Technical Note  
No. 826/15

DG-400

Subject: Powerplant - cable guides

Effectivity: Powered sailplane DG-400  
Serial No. 4-1 up to 4-140

## Power plant - cable guides

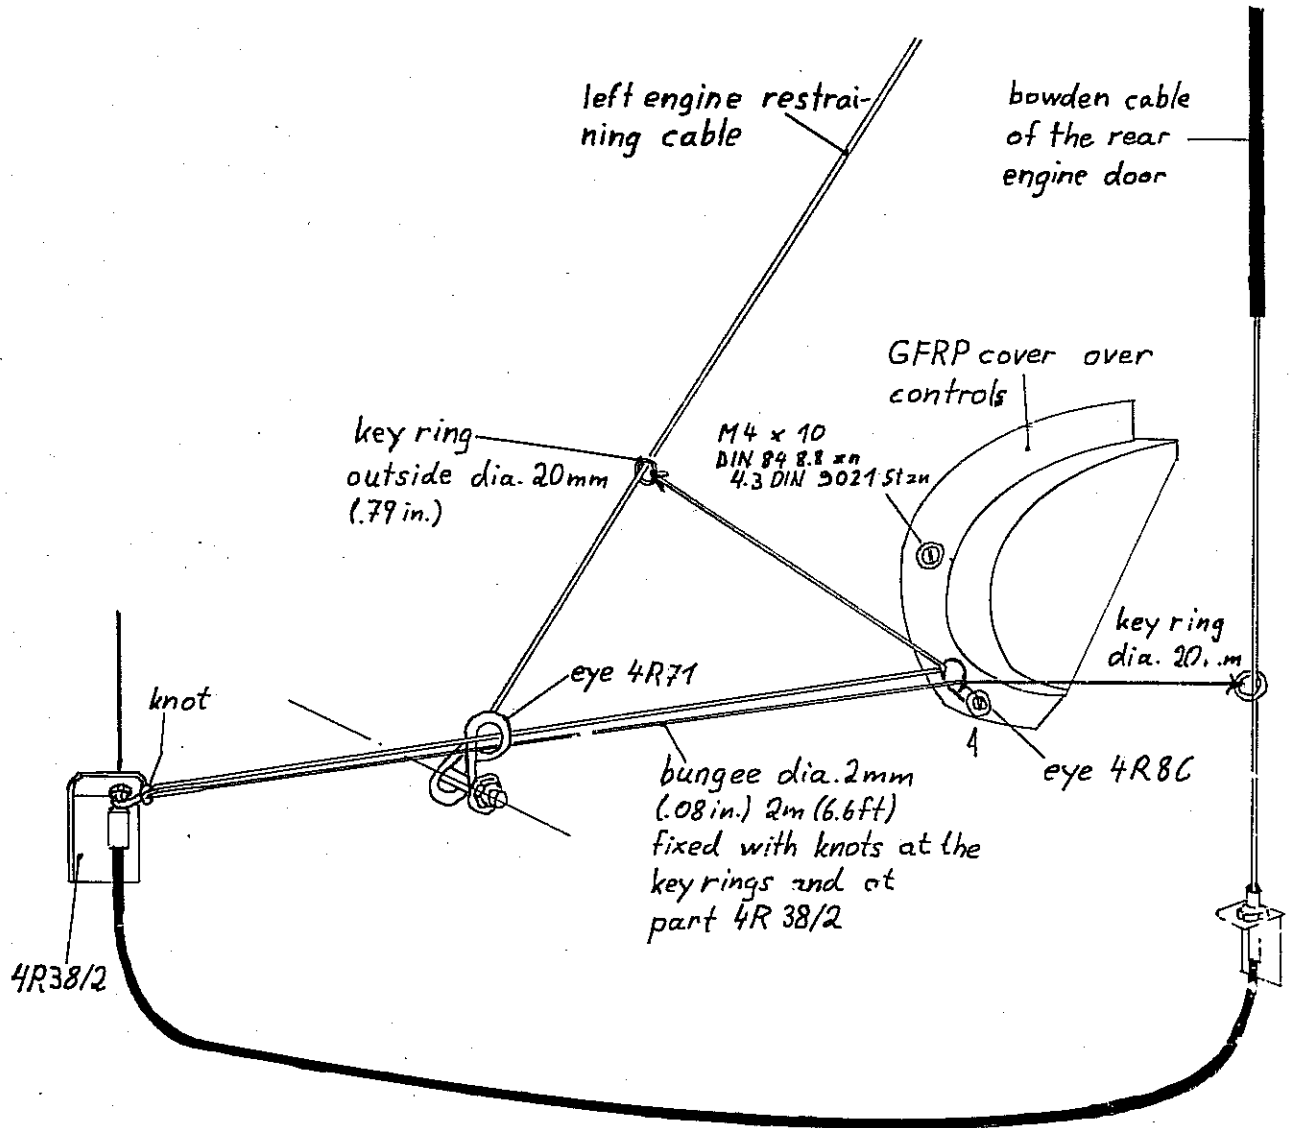
Reason: It is possible under unfavourable conditions that the left engine restraining cable or the bowdencable of the rear engine door may catch the engine and block the engine extension.  
(The right engine restraining cable can not catch the engine as it is wrapped together with the Choke - throttle - propellerbrake - bowdencables).

Instructions: The above mentioned cables will be secured with bungees referring to the enclosed installation plan. The present bungee fixed at the bowdencable of the rear engine door has to be removed.

Don't tighten the bungee too much  
 Make 3 knots everywhere and cut off  
 the excessive bungee.  
 Grease the cables at the key rings  
 with vaseline.

detail A
